Interactive comment on “GO5.0: The joint NERC-Met Office NEMO global ocean model for use in coupled and forced applications” by A. Megann et al.

A. Megann et al.

Received and published: 6 March 2014

Figure 10. (a) Zonal mean net air-sea heat flux in GO1 (black); GO5.0 (red) and CORE2 data (dashed blue line) in years 1996-2005; and (b) surface net downward heat flux difference GO5.0 minus GO1.

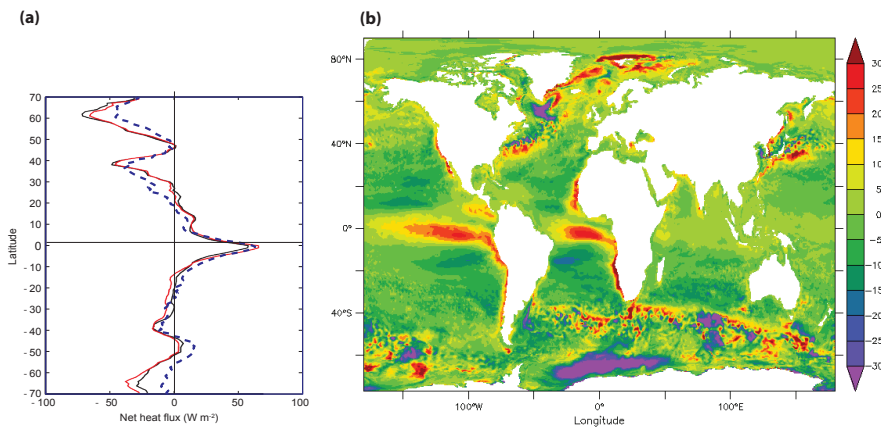
"The paper focus on the surface layer and there is in the text few comments or remarks about the atmospheric forcing, I suggest adding some figures to illustrate impact of the atmospheric forcing which is the main driver of the ocean and which can explain lot of bias discussed in the paper. For example, it will be useful to know how the surface fluxes, computed with the bulk formulae, are impacted in the experiments. Do we have a large difference in the mean fluxes between GO1 and GO5.0?".

P5764 I28: You write that there is no atmosphere ocean feedback in your simulation. As you use bulk formulae there is a feedback and it will be useful to illustrate flux differences between the simulations.

We have added an extra figure (Fig. 10) showing zonal mean heat fluxes from GO1
C2781

and GO5.0 alongside those from the CORE2 dataset, and the 2-D surface difference in the fluxes between GO1 and GO5.0, as well as an extra subsection (5.2.3) discussing them.

The changed surface flux does not correspond to any change in surface air temperature, but we acknowledge that there is limited feedback in the form of a damping term towards the surface air temperature, rather than a true feedback. In this sense the surface flux error diagnoses the tendency of the model to drift away from the climatological SST. We have inserted a new figure (Figure 10) showing the zonal mean heat fluxes and the difference in surface heat flux between GO1 and GO5 and added a subsection (5.2.3) discussing this.
